IFB SA 2614 – Nottoway Tank Site Development

Addendum #1

S-37 REV-2024

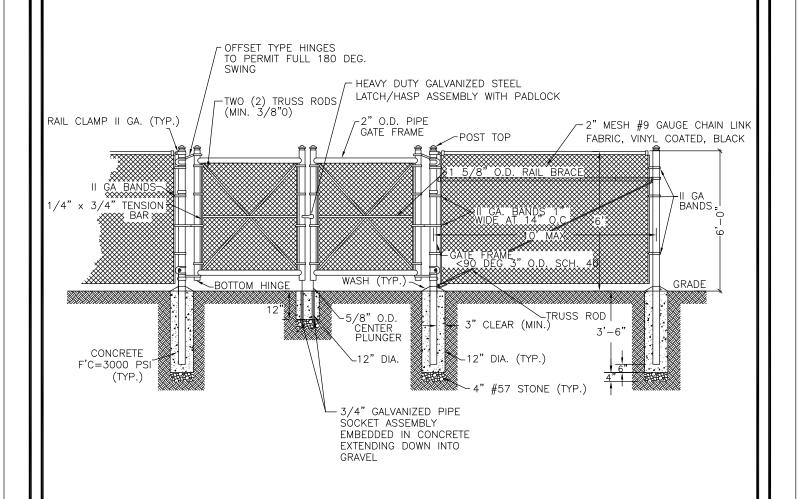
2. Question: Does this job require us to install a chain link fence? Where are the details?

6. Question: There is an 8 ft tall opaque fence shown in the plans, but no detail. Please provide a detail.

7. Question: Is the chain link fence in the spec section 323113 part of the work?

Response: Yes, the fence will be a 6-foot black vinyl-coated chain link fence. The information about the fence can be found in the specifications. Prince William Water Chain Link Fence and Gate detail S-37 is included as an attachment.

Response: Yes, the fence will be a 6-foot black vinyl-coated chain link fence. The information about the fence can be found in the specifications. Prince William Water Chain Link Fence and Gate detail S-37 is included.

Response: Yes. See response #2 and attached document S-37.
